ADDENDUM NO. 1

RE: HIGH SCHOOL #13

Howard County Public School System

Bid Number: 016.20.B4

dwg
ADD_1 P14

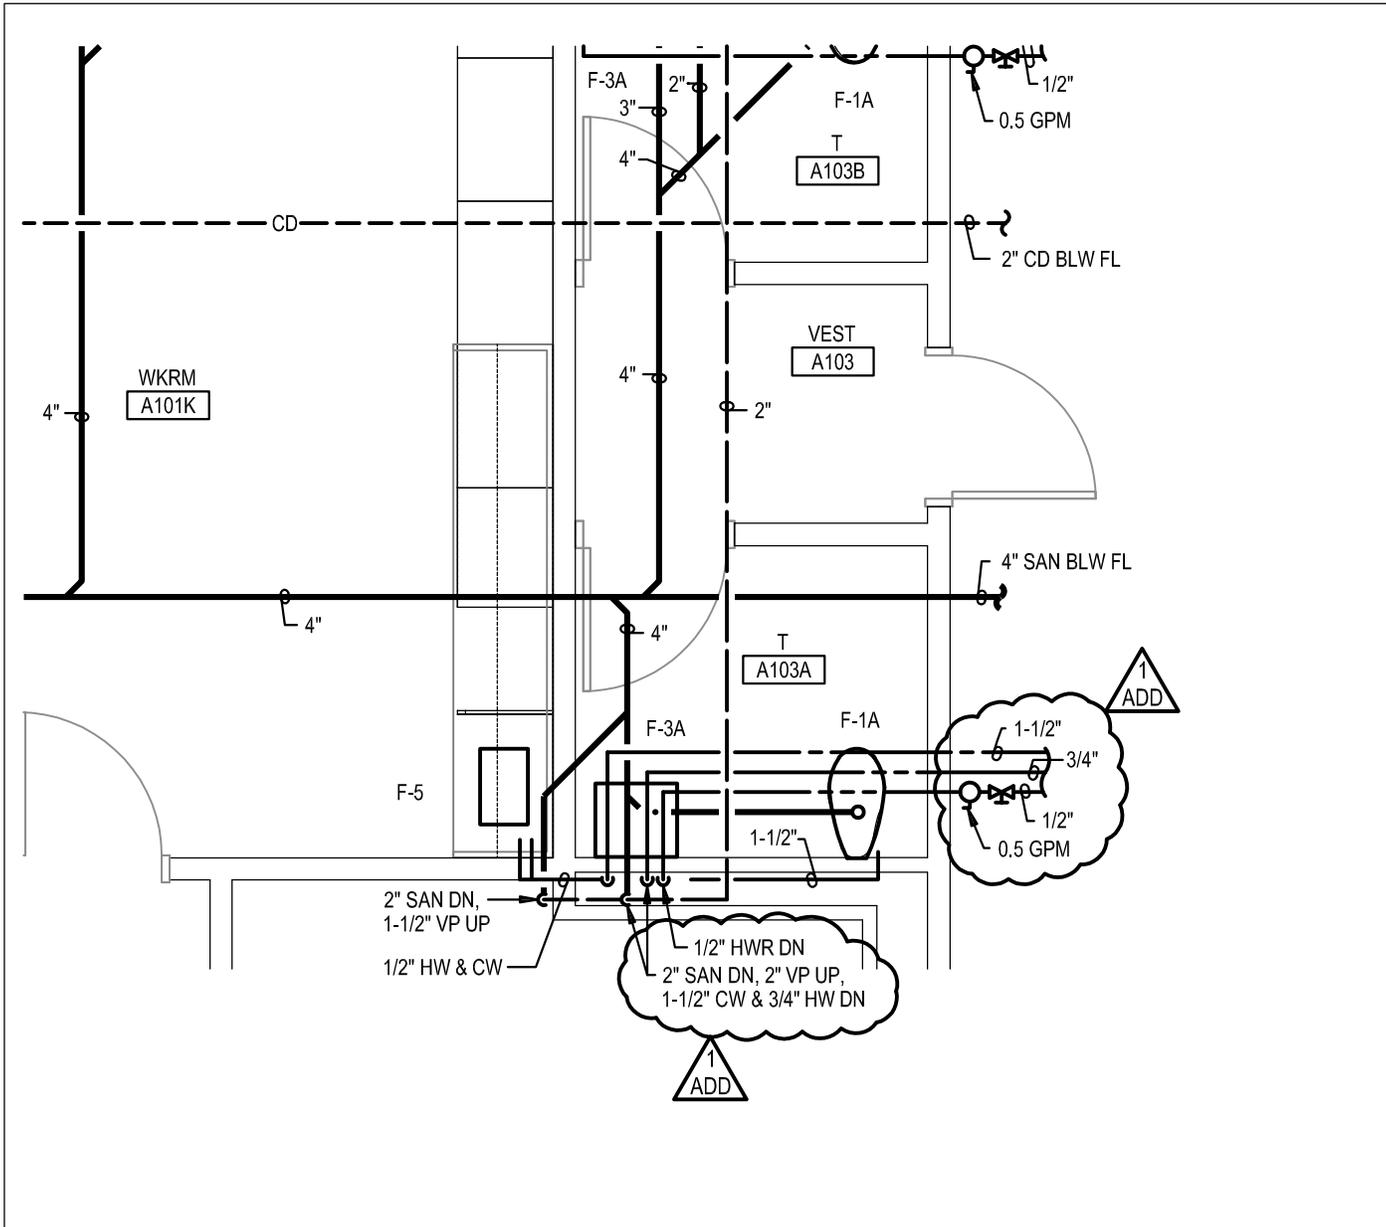
ADD Wall hydrant per sketch ADD_I_P14.

date
 21 JAN 20
dwg
 ADD_1 P15

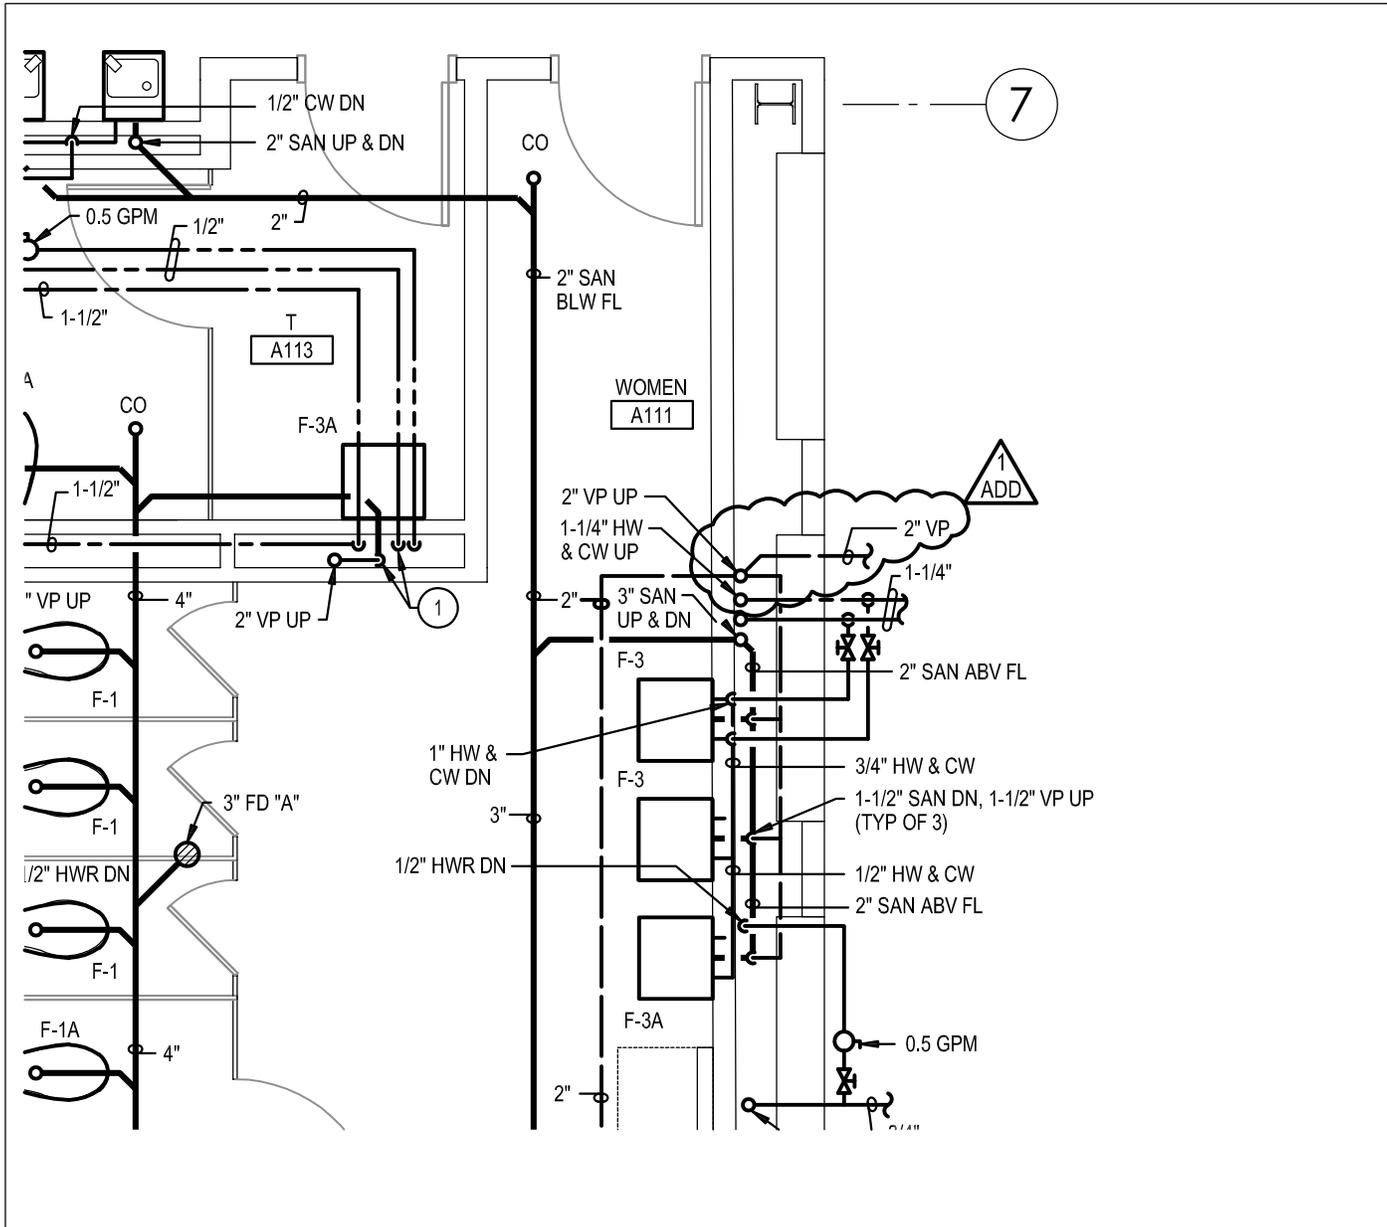
REVISE Pipe size per sketch ADD_I_P15.

dwg
ADD_1 P16

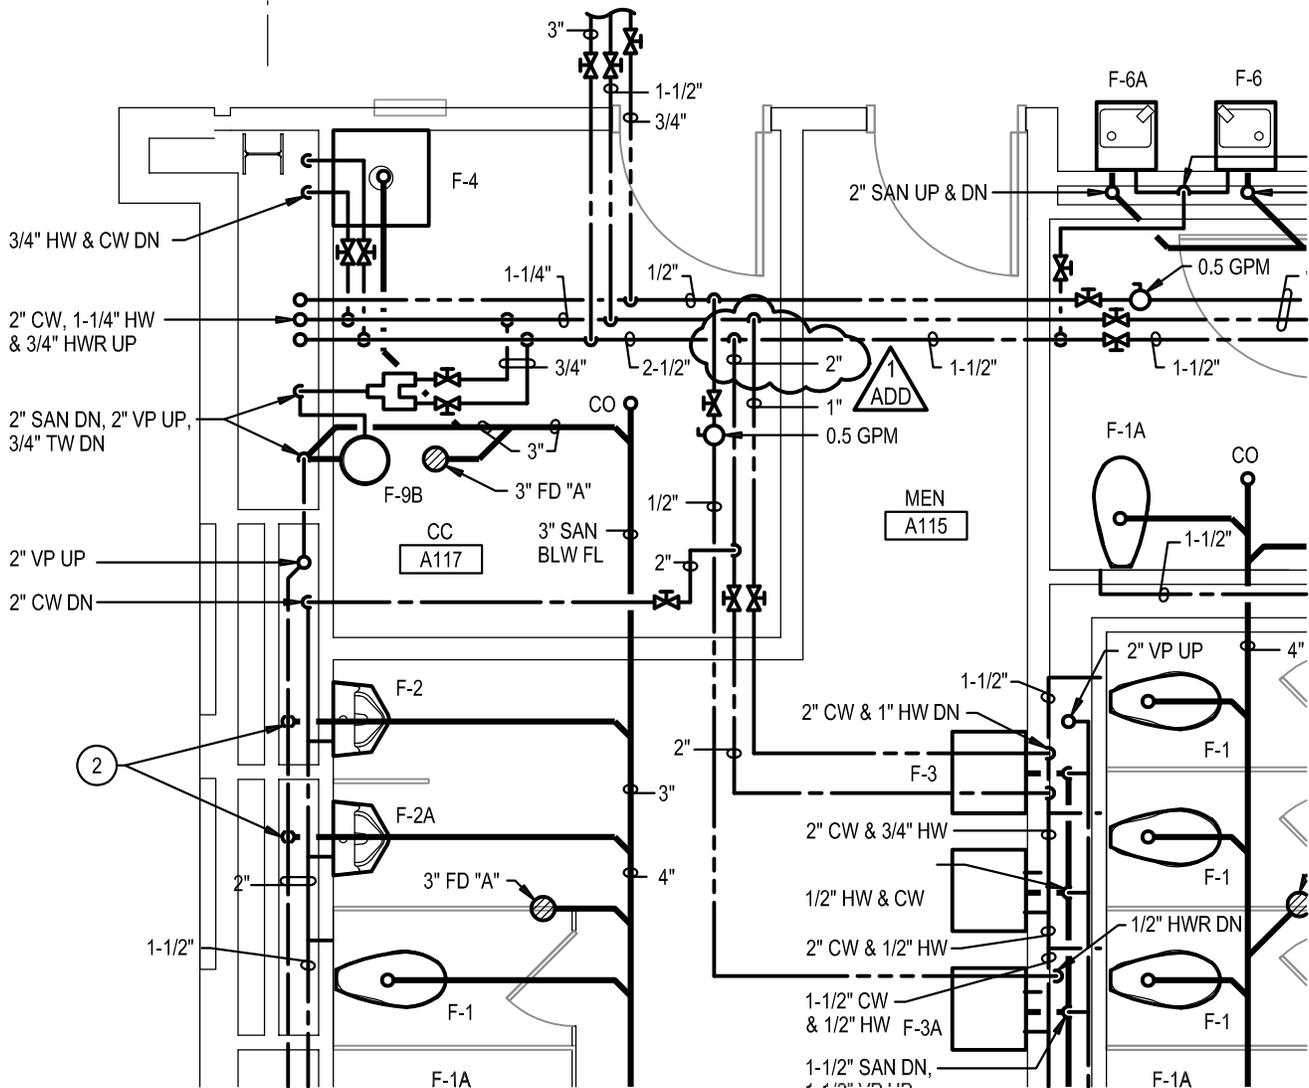
ADD Vent pipe per sketch ADD_I_P16.

date
 21 JAN 20
dwg
 ADD_1 P17

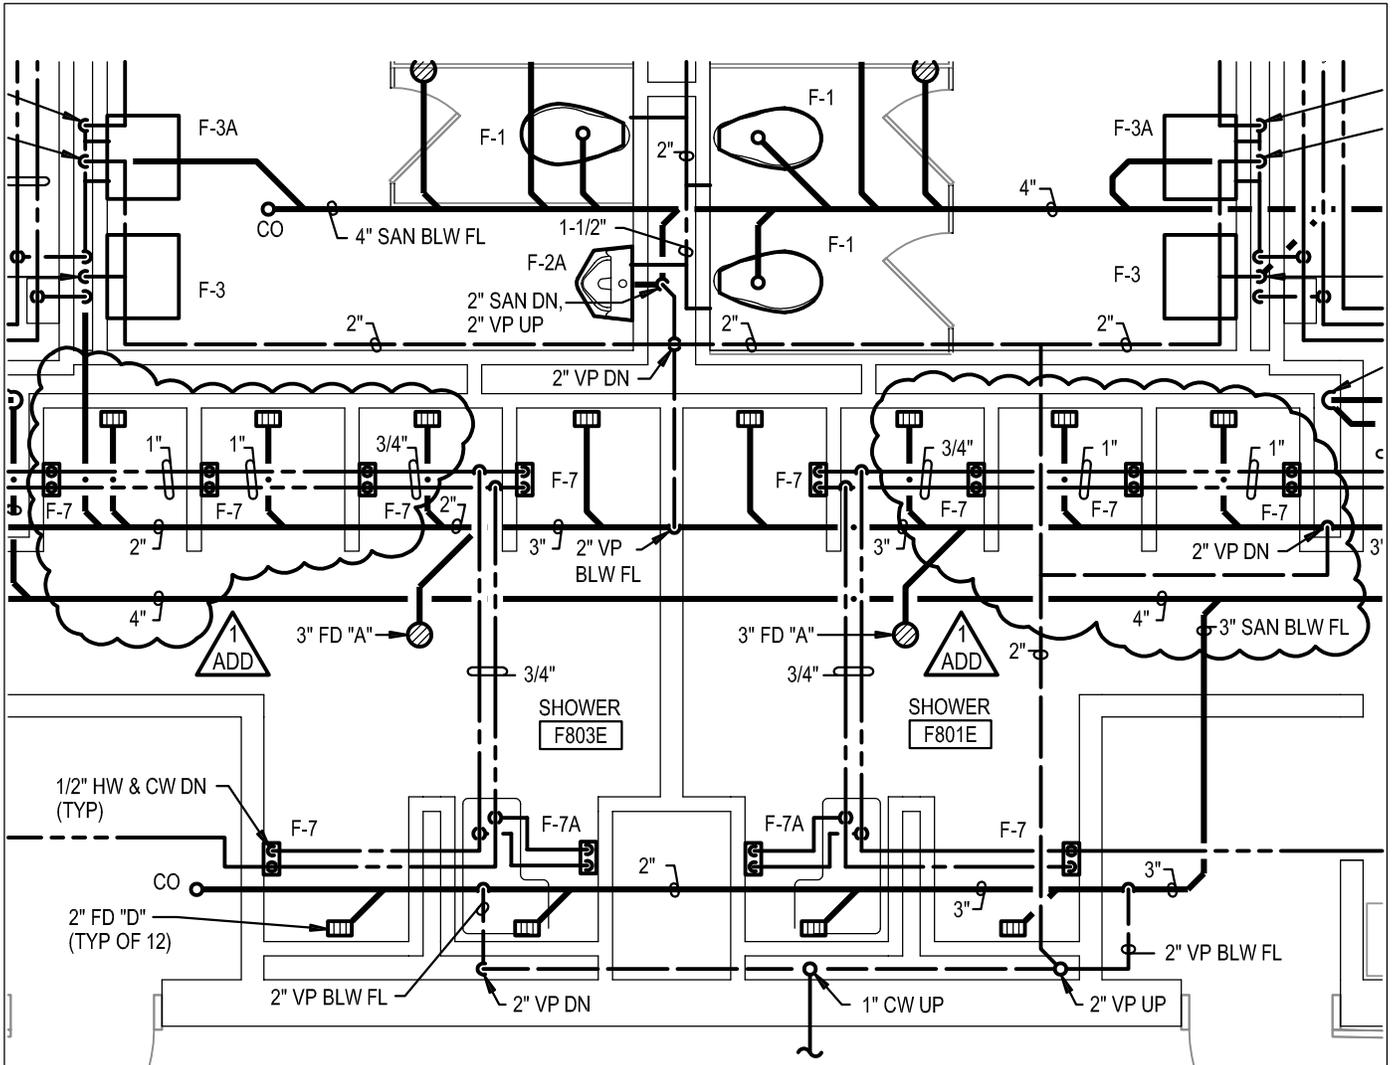
REVISE Pipe size per sketch ADD_I_P17.

dwg
ADD_1 P18

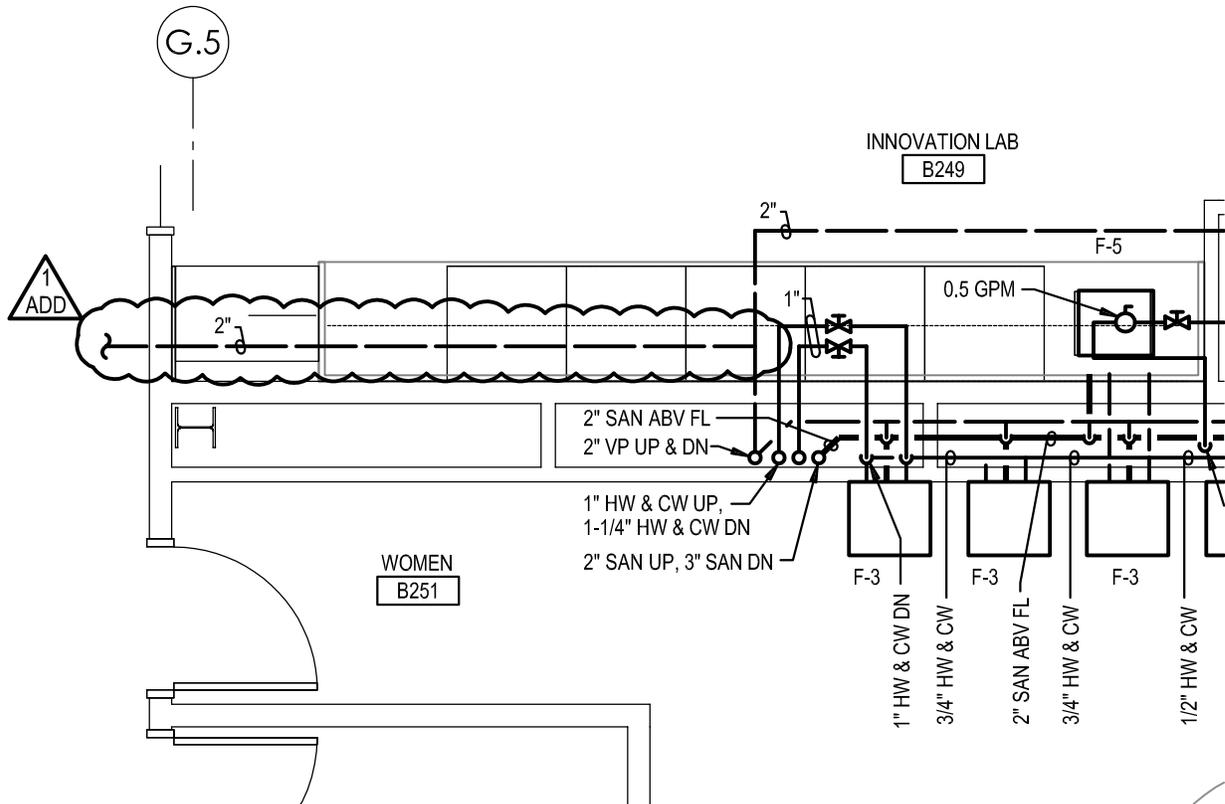
ADD Pipe sizes per sketch ADD_I_P18.

dwg
 ADD_1 P19

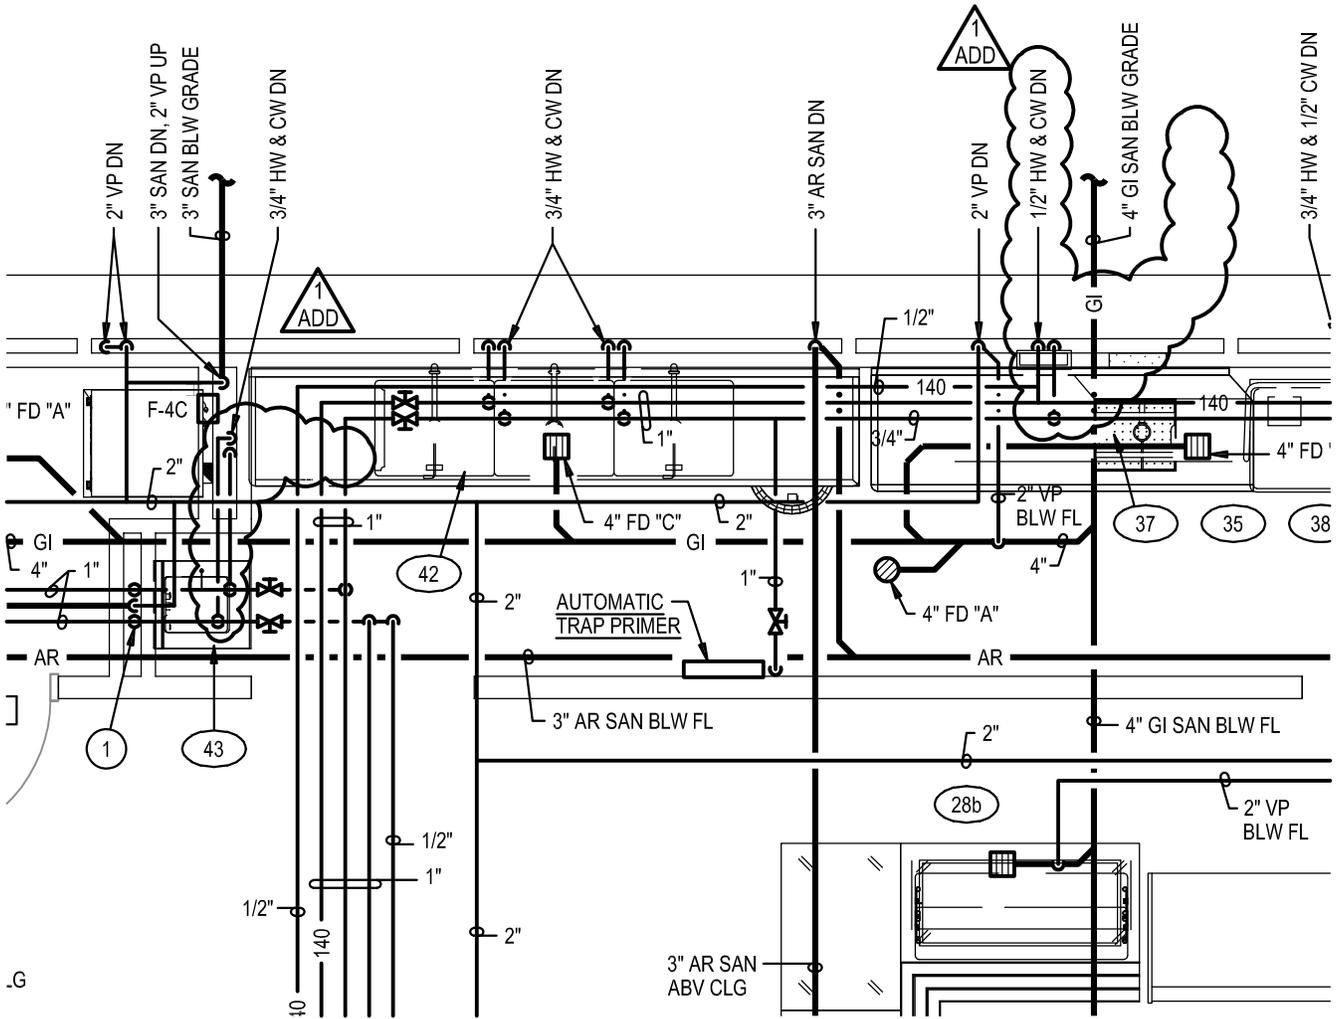
ADD Vent pipe per sketch ADD_I_P19.

date
 21 JAN 20
dwg
 ADD_1 P20

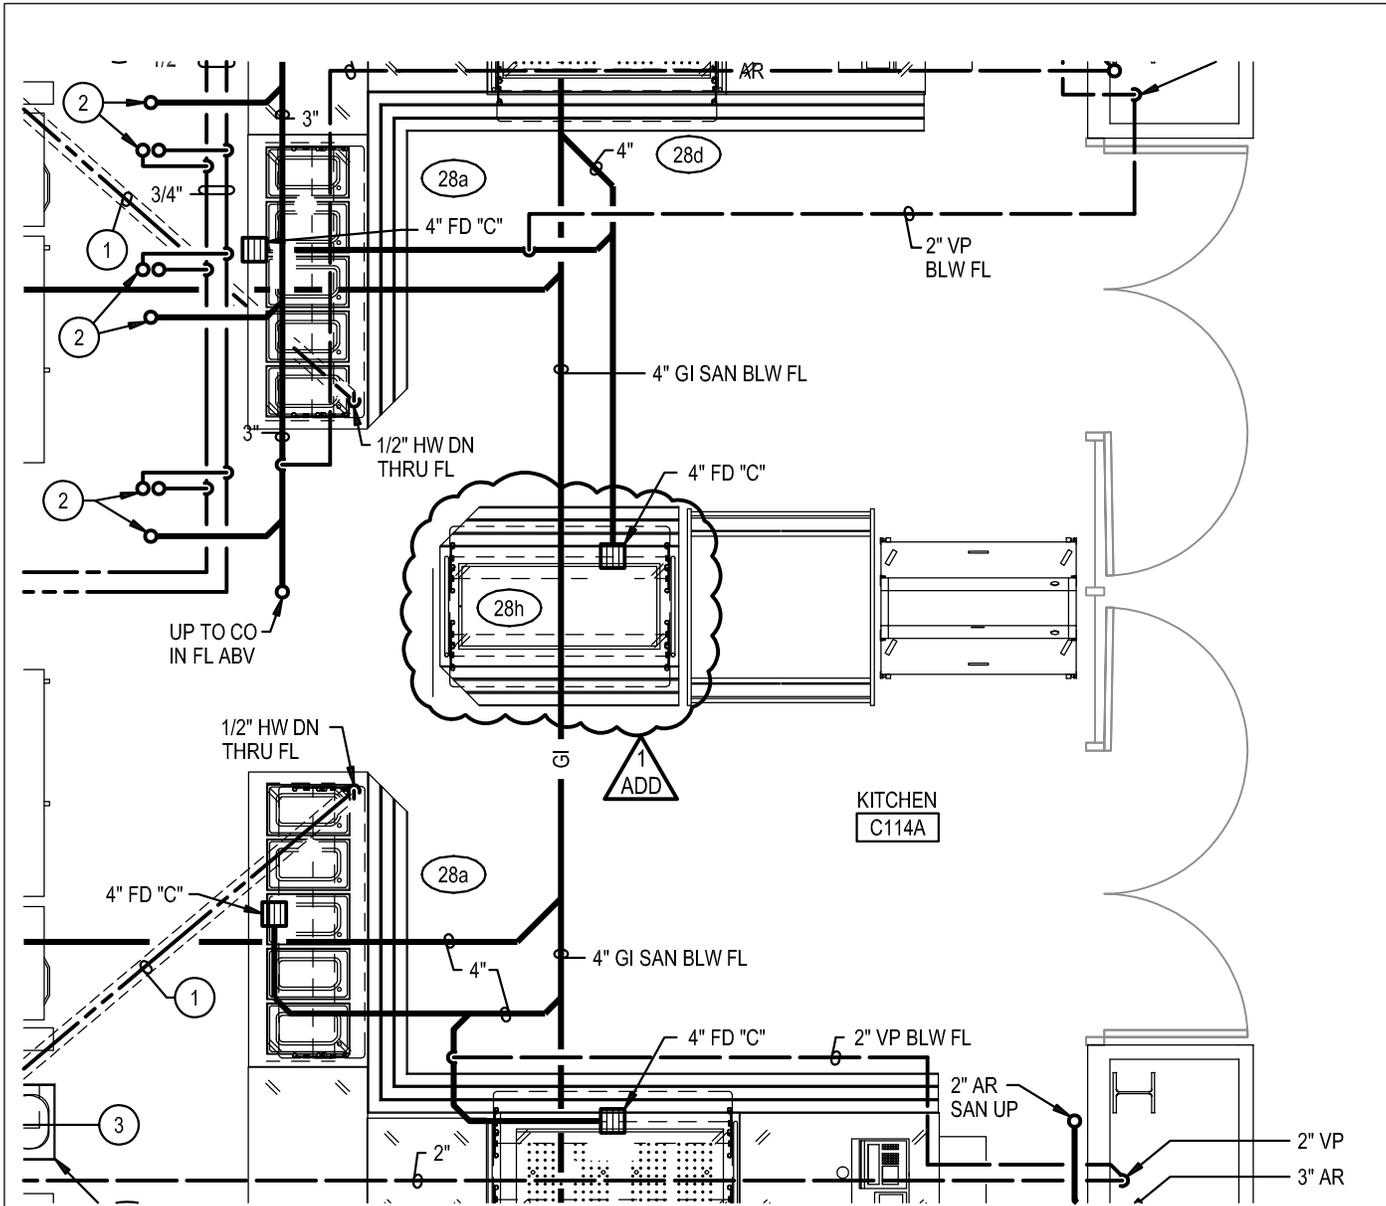
REVISE Pipe locations per sketch ADD_I_P20.
